**Design Review Board Case #2012-0002**  
**Carlyle Plaza Two – South Residential Building**

Application	General Data	
<p><b>Project Name:</b> Carlyle Plaza Two – South Residential Building</p> <p><b>Location:</b> 340 &amp; 350 Hooff’s Run Drive</p> <p><b>Applicant:</b> Carlyle Plaza LLC and FX Fowle, represented by Ken Wire, attorney</p>	<b>DRB Date:</b>	November 19, 2012
	<b>Site Area:</b>	~ 2 acres
	<b>Zone:</b>	CDD#2
	<b>Proposed Use:</b>	Residential
	<b>Gross Floor Area:</b>	~ 350,000 sf
<b>Purpose of Application:</b>		
Concept design review of the first phase of the Carlyle Plaza Two development (south residential building).		
<p><b>Staff Reviewers:</b> Thomas H. Canfield, AIA <a href="mailto:tom.canfield@alexandriava.gov">tom.canfield@alexandriava.gov</a>  Gwen Wright, <a href="mailto:gwen.wright@alexandriava.gov">gwen.wright@alexandriava.gov</a>  Gary Wagner, RLA, <a href="mailto:gary.wagner@alexandriava.gov">gary.wagner@alexandriava.gov</a>  Katie North, AICP, LEED AP <a href="mailto:katie.north@alexandriava.gov">katie.north@alexandriava.gov</a></p>

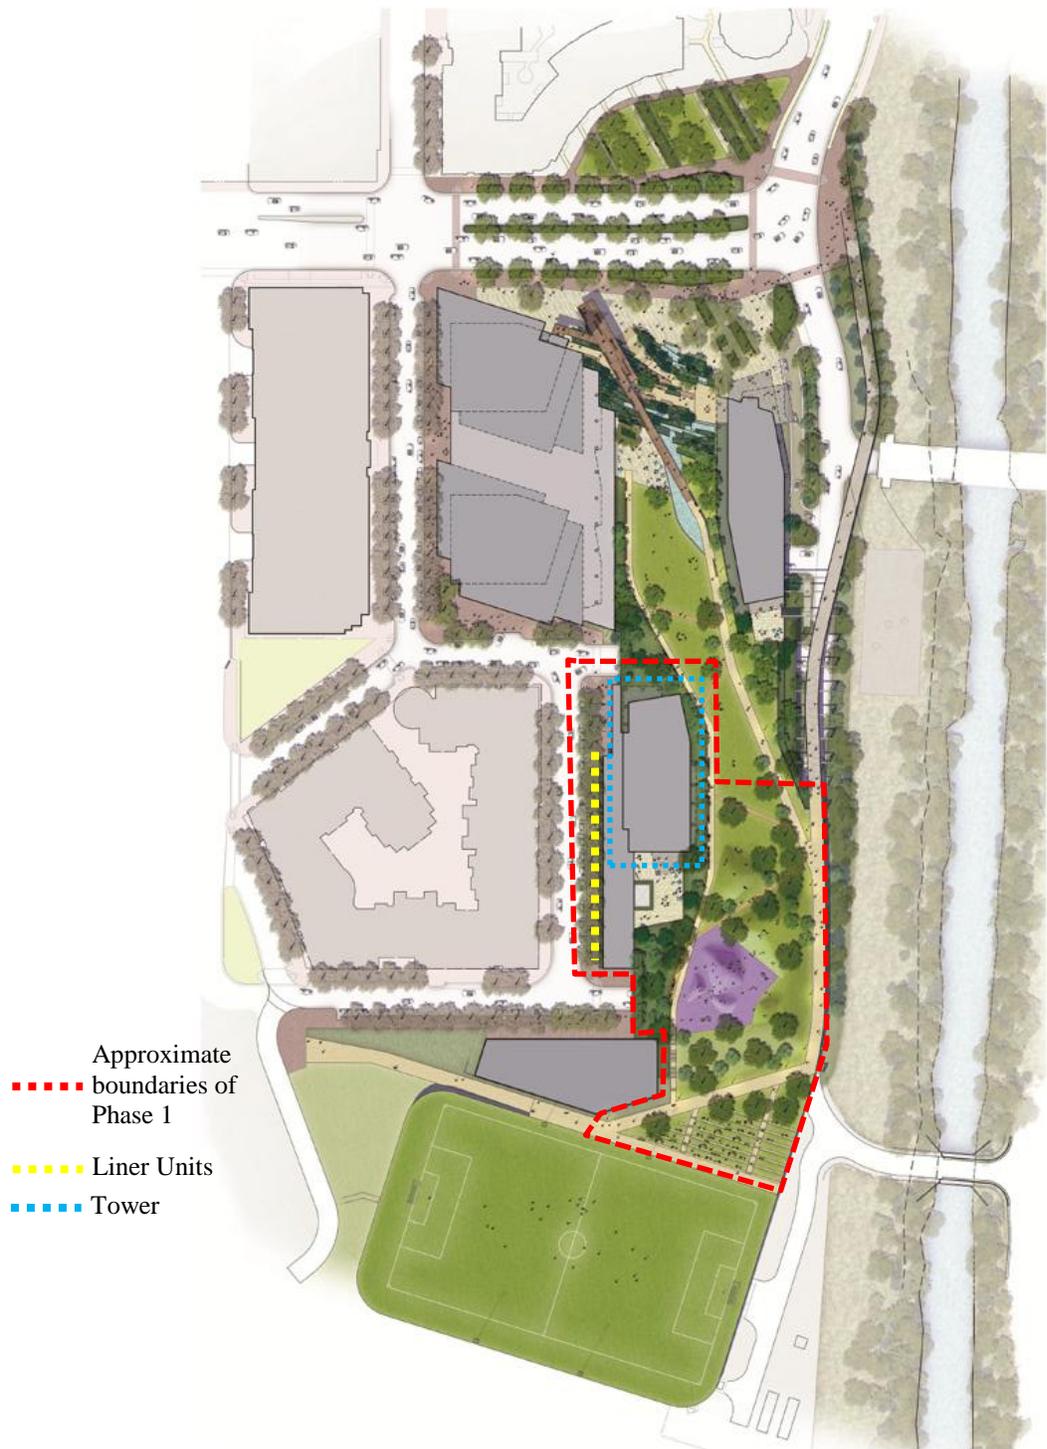
- *Liner Units:* A number of sketches have been provided to show the concept for the liner units along Bartholomew Street. In general, staff is pleased with the direction of the design for these units. The height and scale of the units appears compatible with the 5-story building across Bartholomew Street. The angled bays along the street wall provide an interesting design that also allows for additional light within the units. Staff recommends continued refinement of this elevation and study of the materials that will be used.

- *Tower Massing:* Preliminary massing diagrams and elevations have also been provided for the tower component of this plan. While staff likes the slender width of the building, the overall length and massing need further study. As shown, the building appears somewhat boxy and long along the north-south direction. The original concept plan showed footprints with oblique angles for the proposed buildings which should be carried forward in this plan. As a suggestion, the geometry of the liner units could be incorporated into the larger design of the tower to tie to the two pieces together. Additionally, although difficult to tell the intent for materials for the tower, staff recommends using glassy elements to create interesting planes and shapes along the façade.
